U.S. NUCLEAR REGULATORY COMMISSION
REGION IV

Report No.: 50-445/97-09
50-446/97-09

Facility: Comanche Peak Steam Electric Station, Units 1 and 2

Comanche Peak Steam Electric Station, Units 1 and 2
NRC Inspection Report 50-445/97-09; 50-446/97-09

Figure 1 Anomaly at the top of the tube sheet for tube Row 49 Col 51

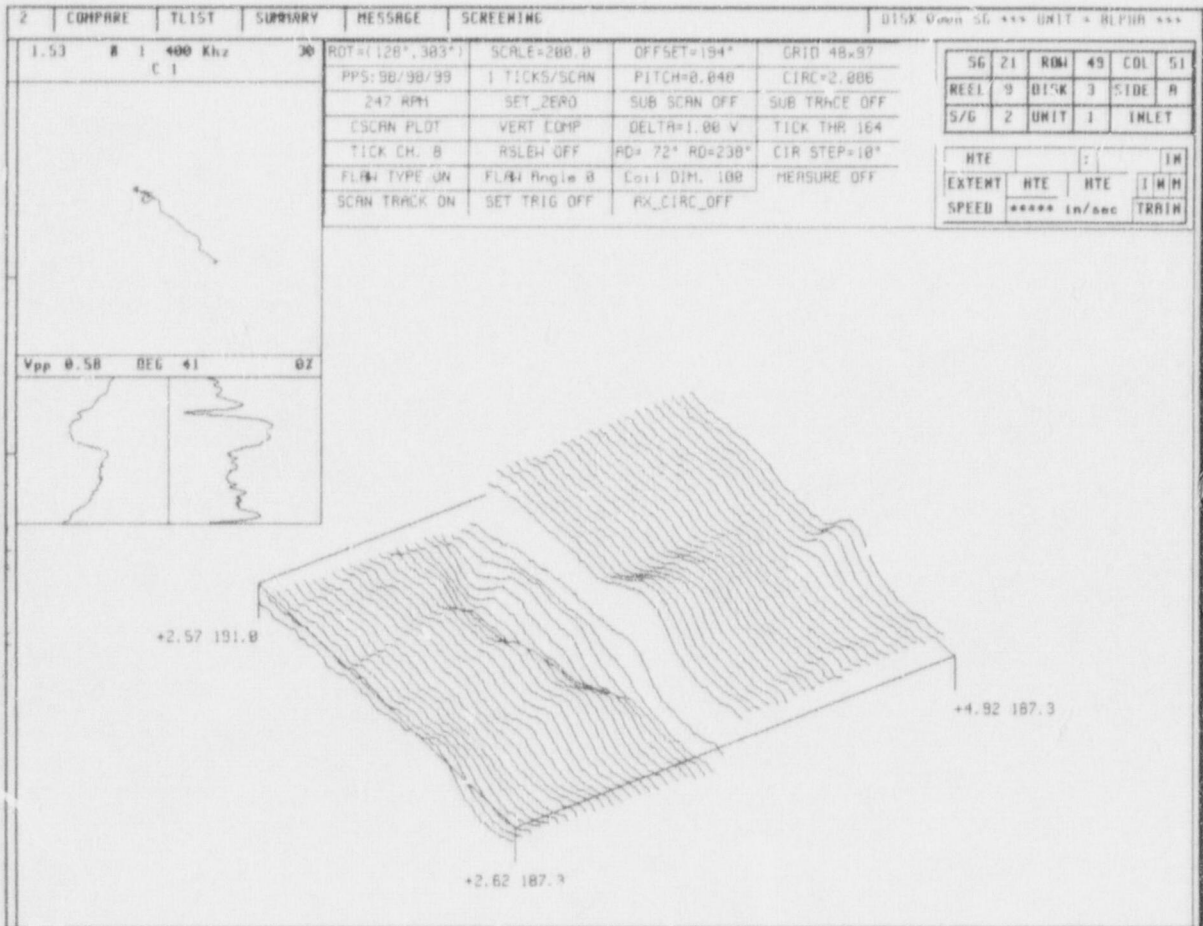
sensitive coil. These tubes showed long signals in the axial direction that had "bumps" at regular intervals. The NRC consultant reviewed the 1995 data from the following Steam Generator 2 tubes that exhibited this anomaly: R45, C43; R47, C55; R49, C51; and R49, C61. The phase of these signals was observed to not rotate like a defect above or below the tube sheet as the frequency was changed. However, the intersection of these signals with the expansion transition region did produce a signal on some of the frequencies that could be interpreted to represent a defect with an approximate inside diameter location. The licensee concluded in 1995, after detailed review and performance of supplementary ultrasonic examinations, that the signal anomalies were not evidence of the presence of defects. The NRC consultant reviewed the data produced for the same tubes in the 1996 Refueling Outage 1RF05 examinations. These examinations were performed using a probe containing a plus point coil and two pancake coils. (See Section E1.1 below for additional probe information). The signal was noted to be present in the data from the pancake coils, and greatly reduced in the plus point data (particularly away from the expansion transition region). Figure 1 shows an example of the signal anomaly as exhibited by the plus point coil. Figure 2 shows the phase for an anomaly at different frequencies. In some instances, a small, low-voltage defect-like signal could be found on the plus-point channel in this region, but it was well within the noise. The NRC consultant concurred with the licensee position that the available information did not support classification of these signal anomalies as defects. The inspector considered the only feasible method for determination of the reasons for the anomalies would be removal of a tube sample from a steam generator for laboratory examination.

Figure 3 Defect at the top of the expansion transition showing an id phase at 600 kHz

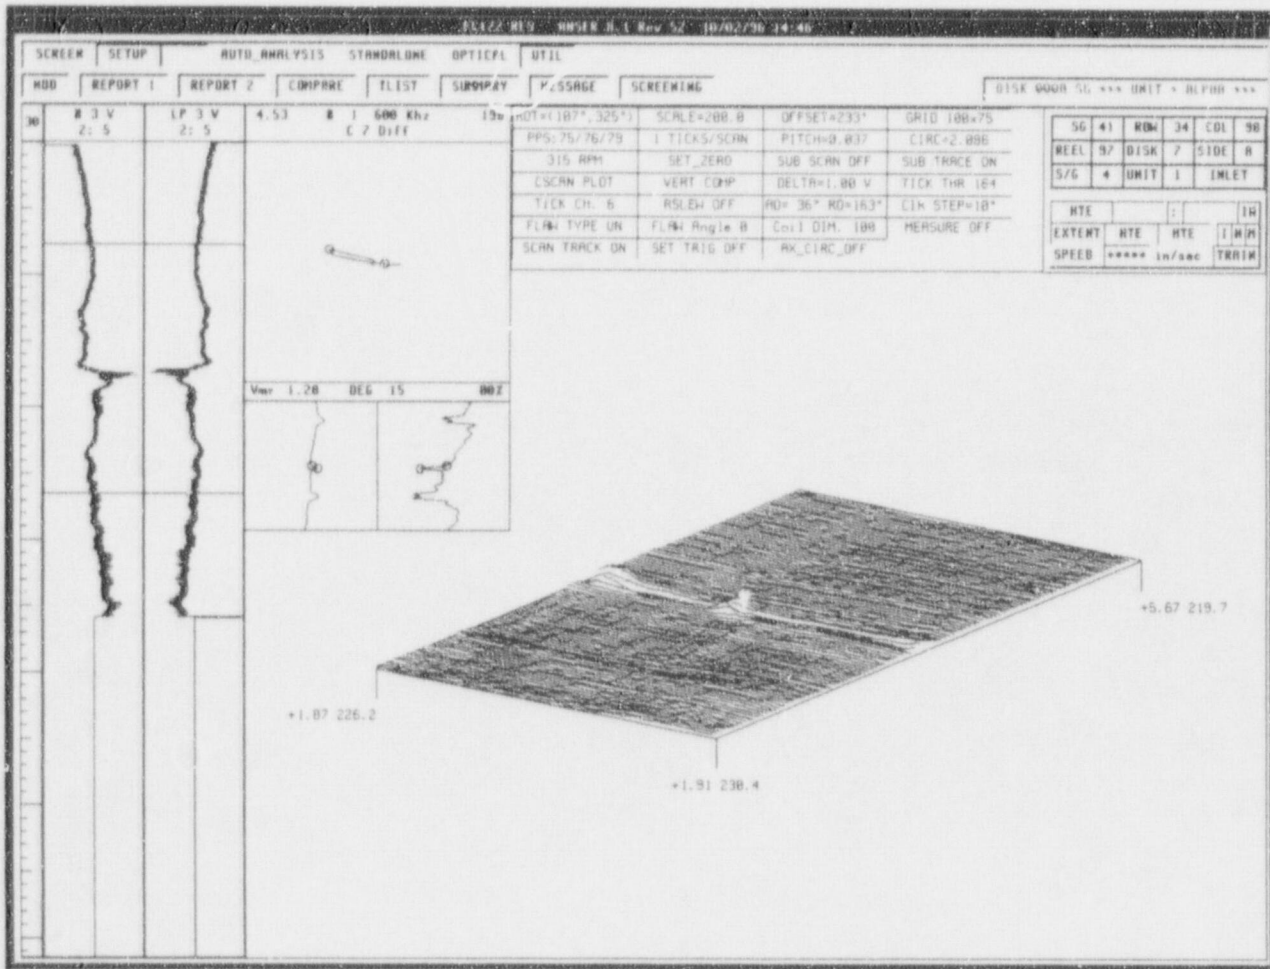
The NRC consultant reviewed the eddy current data from the following tubes, which had been called as containing defect indications and subsequently plugged: Steam Generator 2 - Tubes R23, C44, R43, C47, and R1, C98; Steam Generator 4 - R26, C104 and R34, C98. All of the calls appeared to be correct with one exception. The NRC consultant determined that Tube R34 C98 of Steam Generator 4 appeared to contain an inside diameter axial crack rather than the outside diameter axial crack that was called. Eddy current information for this defect indication is shown in Figures 3 and 4. There were two axial cracks noted to be present, with one of them close to 100 percent through the wall. Most of the data indicated an inside diameter indication, with the 0.080-inch pancake coil further confirming inside diameter cracking by exhibiting a larger signal at a 800 kHz frequency than that shown at 600 kHz.
